# Access Compliance Report

## Public Rights-of-Way

Intersection ID: 3097	Main Street: PLACER MAPLE LN	Cross Street: ALLEN A BROWN RD	Location: SE
ADA ID: B6449FD72ABB	Ramp Type: Perp	Initial Pass/Fail: Fail	Overall Compliance: No
Codes/Mitigation Info/Possible Solution			Severity Score: 10
			Field Measurements/Component Compliance

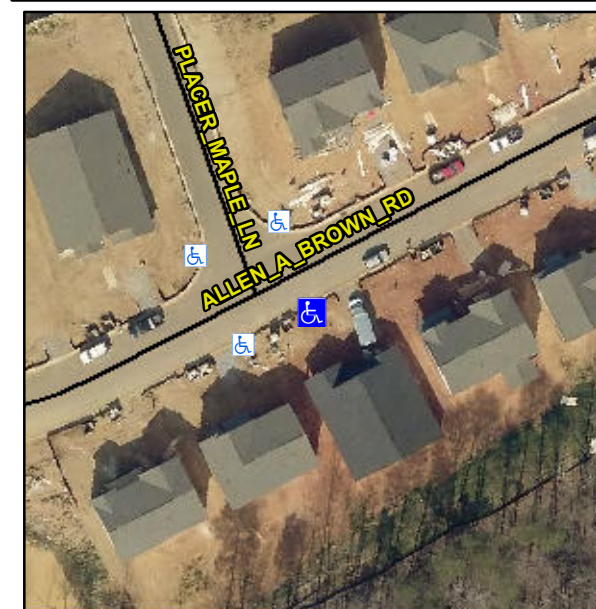
**Not Found, R304.5.1**

Compliance	Description	Data	Compliance	Description	Data
N/A	Ramp Length (in)	48.0	Yes	Ramp Slope (%)	6.7
No	Ramp Width (in)	47.0	Yes	Ramp XSlope (%)	2.4
N/A	Flare Type LT	N/A	N/A	Flare Type RT	N/A
N/A	Flare Slope LT (%)	N/A	N/A	Flare Slope RT (%)	N/A
N/A	Flare Traversable LT?	N/A	N/A	Flare Traversable RT?	N/A
N/A	Landing Length (in)	N/A	N/A	DWS Provided?	N/A
N/A	Landing Width (in)	N/A	N/A	DWS Contrast?	N/A
N/A	Landing Slope (%)	N/A	N/A	DWS Length (in)	N/A
N/A	Landing X Slope (%)	N/A	N/A	DWS Full Width?	N/A
N/A	Landing Curb? (Y/N)	N/A	N/A	DWS Offset (in)	N/A
N/A	Shared Landing?	N/A			
N/A	Gutter Ponding?	N/A	N/A	Gutter Slope (%)	N/A
N/A	Gutter Lip Ht (in)	N/A	N/A	Gutter X Slope (%)	N/A
N/A	Painted X Walk1?	No	N/A	Painted X Walk2?	N/A
	X Walk 1 Direction	To N		X Walk 2 Direction	N/A
N/A	X Walk 1 Width (in)	N/A	N/A	X Walk 2 Width (in)	N/A
	X Walk 1 Slope (%)	3.7		X Walk 2 Slope (%)	N/A
	X Walk 1 X Slope (%)	5.2		X Walk 2 X Slope (%)	N/A

**Remove & Replace Entire Ramp.**
